# Technical Service Bulletin

NUMBER: 09-06-00

Changes To Timing Belt Tensioner Components

1999 - 2000 (GS) Chrysler Voyager (International Market)  
1999 - 2000 (JA) Cirrus/Stratus/Breeze  
1999 - 2000 (JX) Sebring Convertible  
1999 - 2000 (PL) Neon

**FIGURE 1**

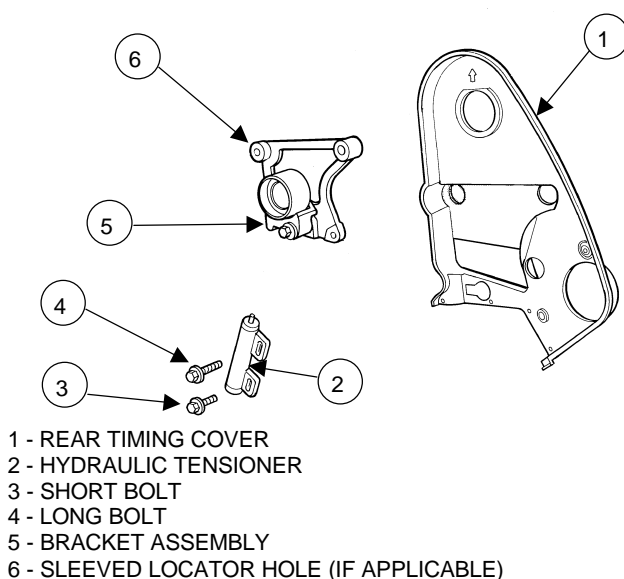
1 5018399AA Kit, Timing Tensioner Component (1999 Models) w/o dowel locator  
1 5018400AA Kit, Timing Tensioner Component (2000 Models) w dowel locator  
Each kit consists of a tensioner w/attaching bolts, tensioner pivot assembly, and rear timing belt cover (Figure 1).

**NOTE: ALL COMPONENTS MUST BE USED IF THE VEHICLE BEING WORKED ON HAS A MECHANICAL TENSIONER. THE FOLLOWING PROCEDURES OUTLINE THE REPLACEMENT OF A MECHANICAL TENSIONER SYSTEM WITH A HYDRAULIC TENSIONER SYSTEM.**

3. Install a new rear cover and bracket assembly, from kit p/n 5018399AA 1999 Models w/o dowel locator or p/n 5018400AA 2000 Models w dowel locator (Figure 1). Torque all applicable bolts to the specifications listed in the service manual.

**FIGURE 2**

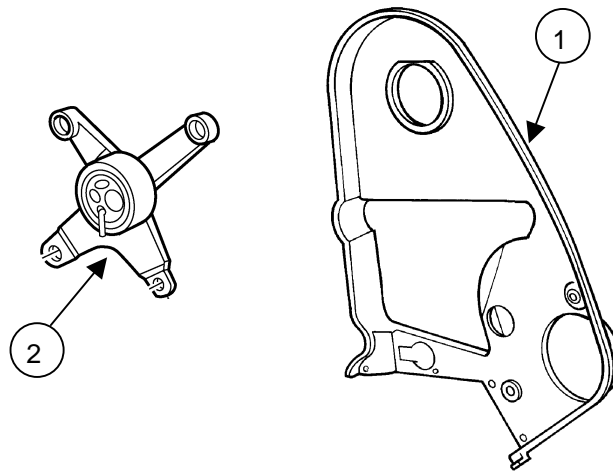
2. Remove and discard the mechanical timing belt tensioner assembly and rear-timing belt cover (Figure 2). Save the bolts that were used to mount the mechanical tensioner to the engine.

1 - REAR TIMING COVER  
2 - MECHANICAL TENSIONER

**FIGURE 3**

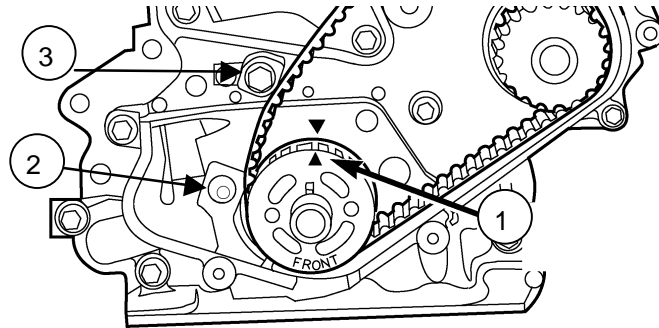
4. Follow the timing procedures (if required) in the service manual up to the point of rotating the crankshaft sprocket to TDC to take up slack in the belt.
5. To install the hydraulic tensioner, first remove and discard the upper bolt as shown in Figure 3. Install the hydraulic tensioner with the 2 bolts from the kit into the location shown in Figure 3. Do not tighten the 2 bolts at this time.

- 1 - CRANKSHAFT SPROCKET  
 2 - OPEN HOLE (POSITION FOR TENSIONER)  
 3 - UPPER BOLT - DISCARD (POSITION FOR TENSIONER)

**FIGURE 4**

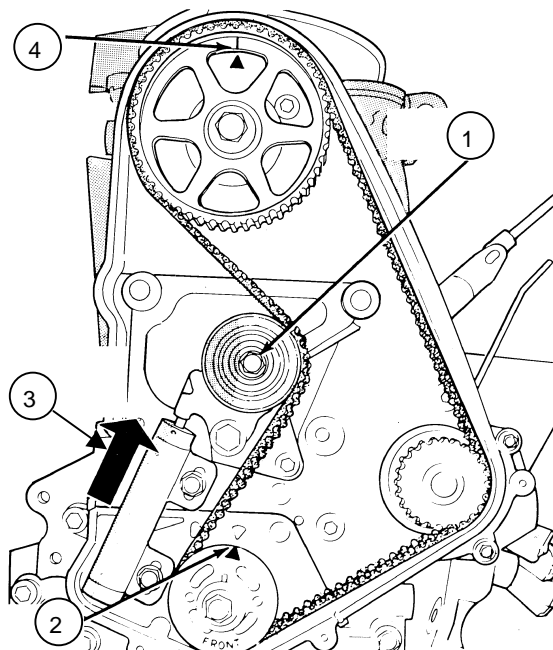
6. Using a torque wrench on the bracket assembly pulley (Figure 4), apply 28 Nm (250 in lbs) of torque against the timing belt.

- 1 - INSTALL TORQUE WRENCH HERE  
 2 - CRANKSHAFT T.D.C.  
 3 - MOVE TENSIONER UP TO REMOVE CLEARANCE  
 4 - CAMSHAFT T.D.C.

7. While torque is being applied to the pulley/belt, move the tensioner up against the bracket assembly and tighten the 2 bolts to 31 Nm (275 in lbs).
8. Pull the tensioner plunger pin. Pretension is correct when the pin can be removed and installed while in location.
9. Rotate the crankshaft 2 revolutions and check the alignment of the timing marks. If alignment is OK, complete the re-assembly of the engine.
